Decision Session - Executive Member for Economy and Transport

- 4. The York Parking, Stopping and Waiting (Pages 13 - 198) (Amendment) (No 14/58) Queen Street, York – Traffic Order 2023**

This report seeks the Executive Member to consider the statutory consultation to a traffic regulation order which has been advertised. The proposal includes the removal of the residents parking in front of the terraced cottages on Queen Street, York.

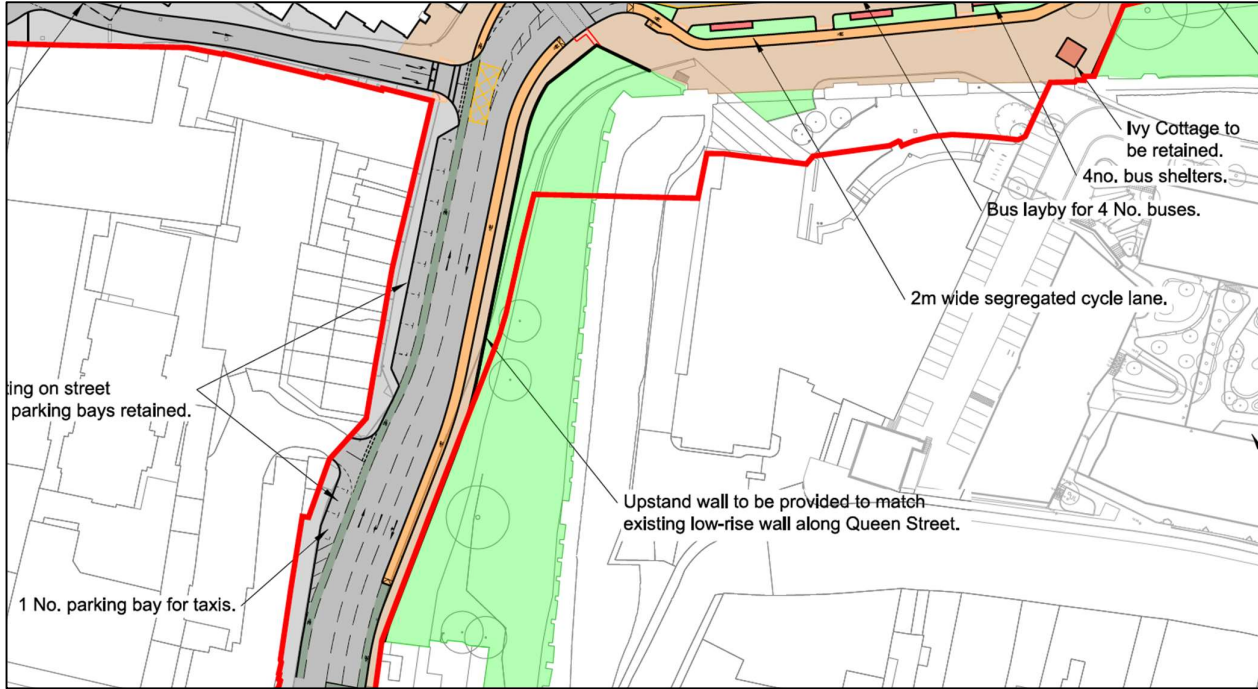
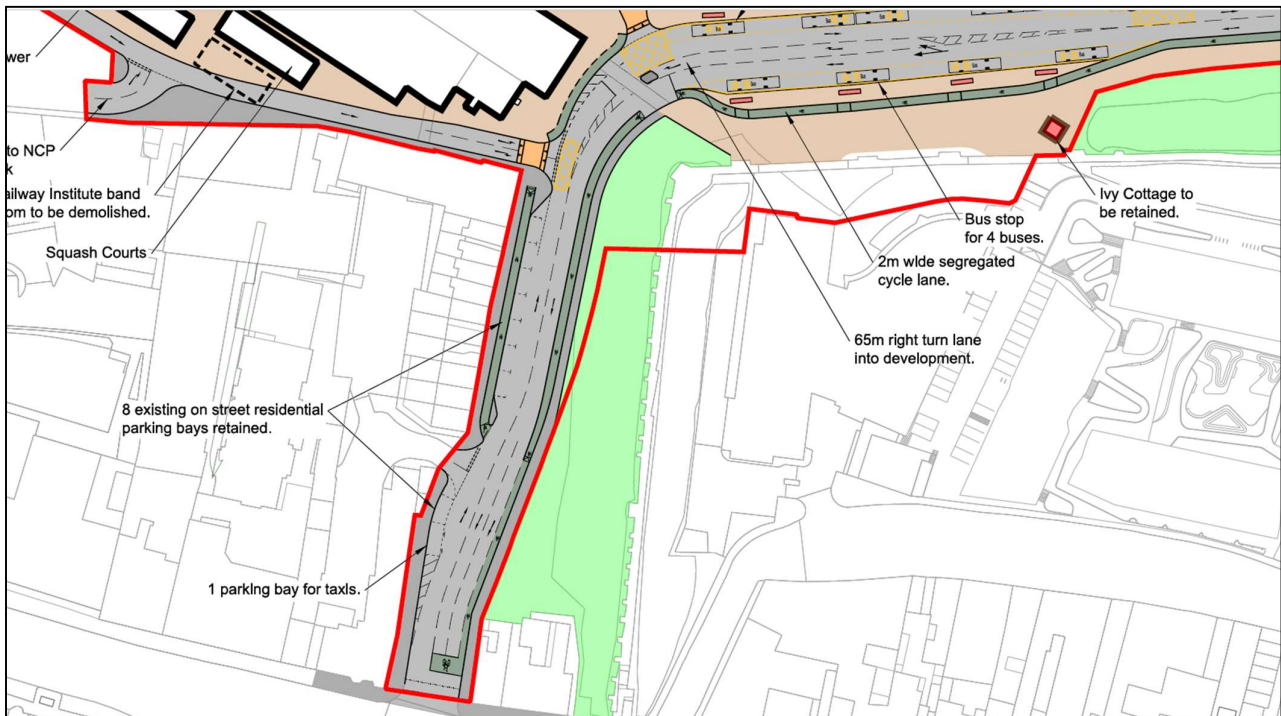
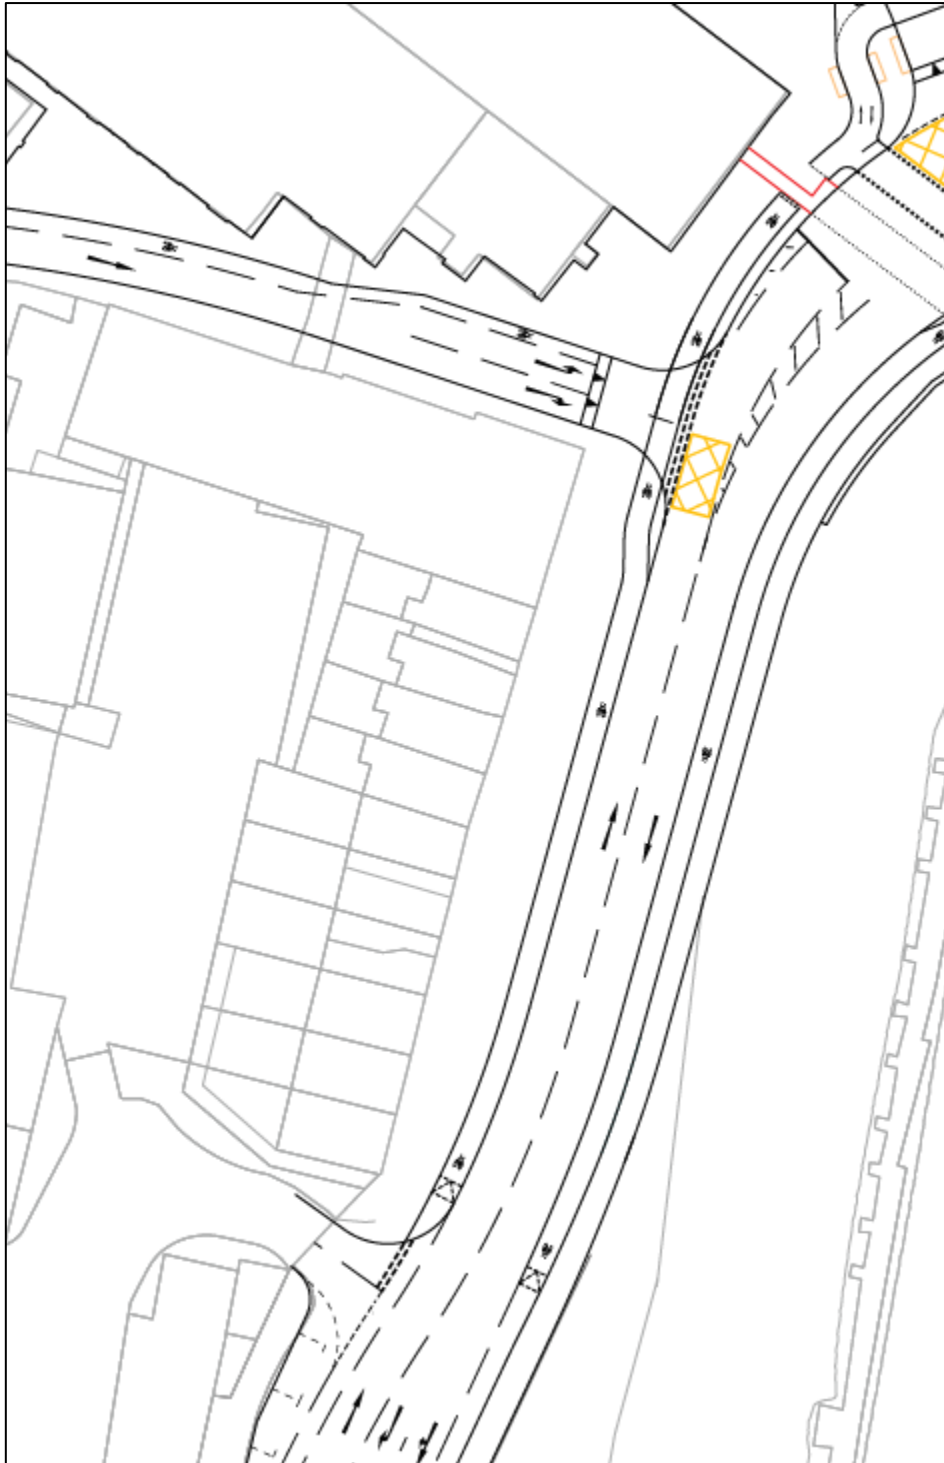
The options presented for review offer different solutions to provide a link within a larger cycle route. Each option forces cyclists to mix with another road user, motor vehicles in option 1 and pedestrians in options 2 and 3. Cyclists can mix with both of these in the right environment and with adequate space. However, options 1 and 2 also include parking for local residents who have no alternative off street parking. This element introduces a variable which creates potential issues for cyclists using an off-road route (option 2).

The increased pedestrian flow along the footway suggests that mixing cyclists with pedestrians at this location could lead to overcrowding on the remaining footway width. This could be exacerbated by the doors to the terrace properties some of which are accessed directly from this footway. Additionally the need to access vehicles from the kerbside rather than the carriageway introduces further risks to option 2 as well as further narrowing the available footway / cycleway width, albeit over short sections. These issues will all make the route less desirable for the majority of cyclists and lead to many of them choosing to stay on road but without the provision which option 1 provides.

Option 3 doesn't provide any parking within the highway directly in front of the properties, which removes many of the issues which are created by options 1 and 2. The remaining width of footway is suitable for the amount of pedestrian traffic whilst still providing space for residents to use their front doors. However, the combined footway cycleway is so wide that some residents may choose to mount the kerb and park here unless it is well enforced or further measures are provided to stop this.

After considering all options and the pros and cons associated with them, it is recommended that removing the residents parking from Queen Street and keeping cyclists off-road would provide the safest solution. This option minimises the conflict between different users which should help to maintain safety. Parking restrictions for the area will need careful consideration and enforcement, alternatively the provision of other measures to ensure the area is kept free of parked vehicles may be required.

Current proposal:

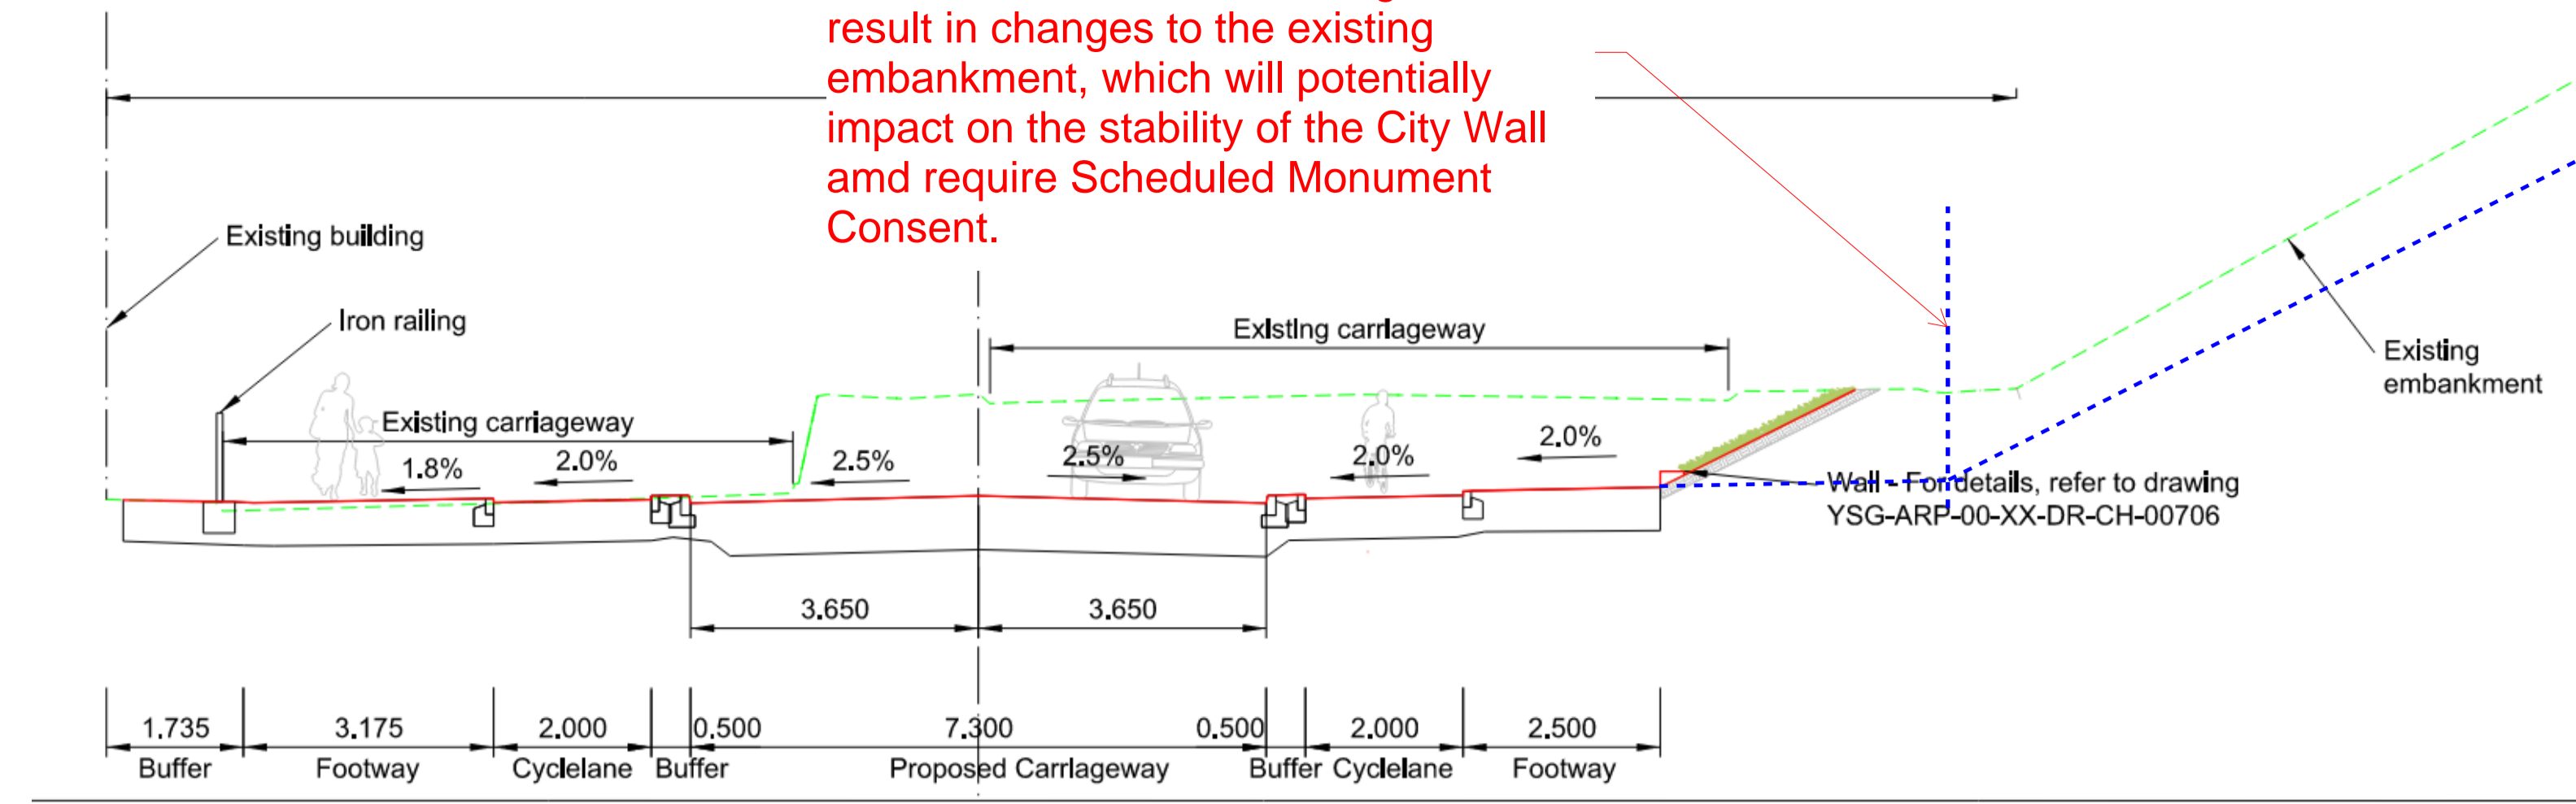
- 1.5m from residents to railing
- 2.45m minimum footway width
- 2m wide segregated cycleway with 0.5m buffer to the carriageway

The visibility splays are 2.4m x 43m in accordance with Manual for Streets.
